**Subject: Comments on Revised Tentative Waste Discharge and Water Recycling Requirements (WDRs/WRRs) for Leo J. Vander Lans Water Treatment Facility and Alamitos Barrier Recycled Water Project (Order No. R4-2014-xxx, CI-8956)**

### Comments on Revised Tentative Waste Discharge and Water Recycling Requirements for Leo J. Vander Lans Water Treatment Facility and Alamitos Barrier Recycled Water Project (Order No. R4-2014-xxx, CI-8956)

FIGURE 4- PROCESS FLOW DIAGRAM

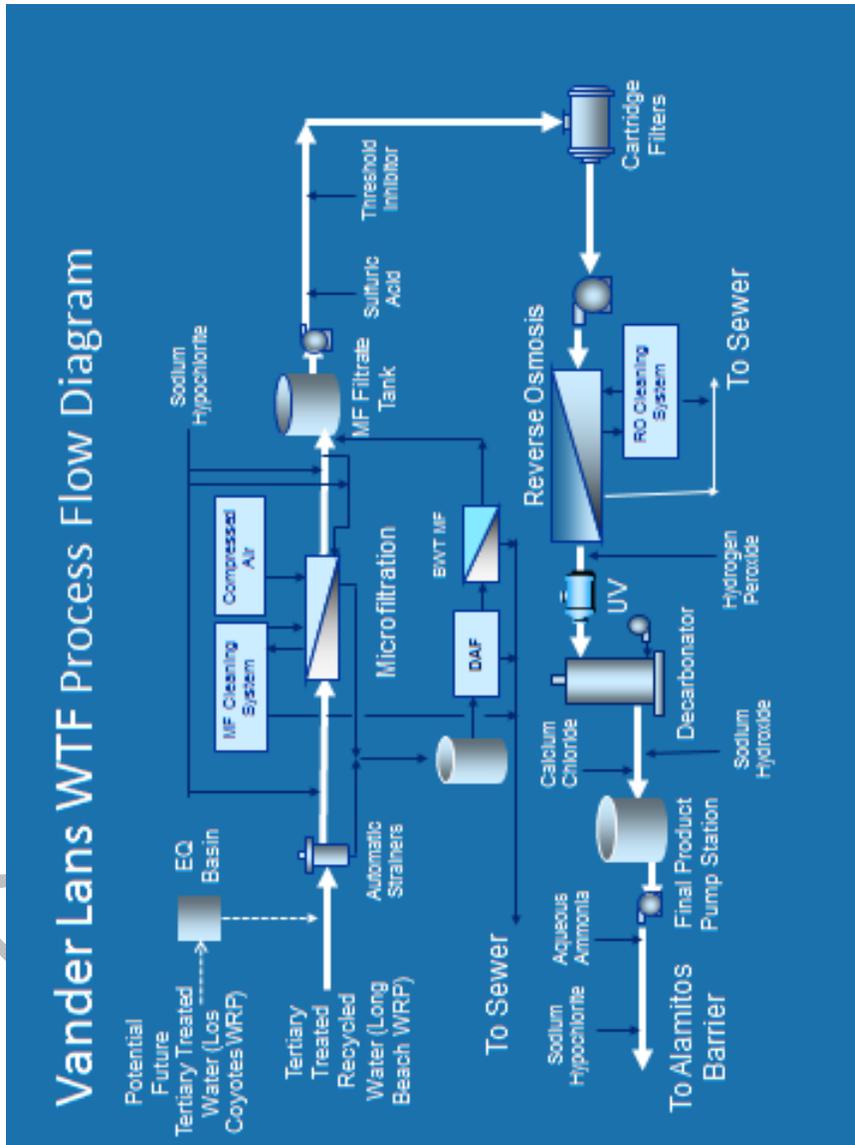
**Commented [A13]:** Per Talking Point #4 (Project Mischaracterization / Unfavorable Depiction of Project), this statement is not factually correct. The current AWTF does not provide advanced oxidation, only UV. As part of the expansion, and to be evaluated during start-up, WRD will add hydrogen peroxide upstream of UV so the treatment system provides advanced oxidation. This change is consistent with the findings in Amendment R4-2005-0061-A01. Suggest rewording entire paragraph as shown.
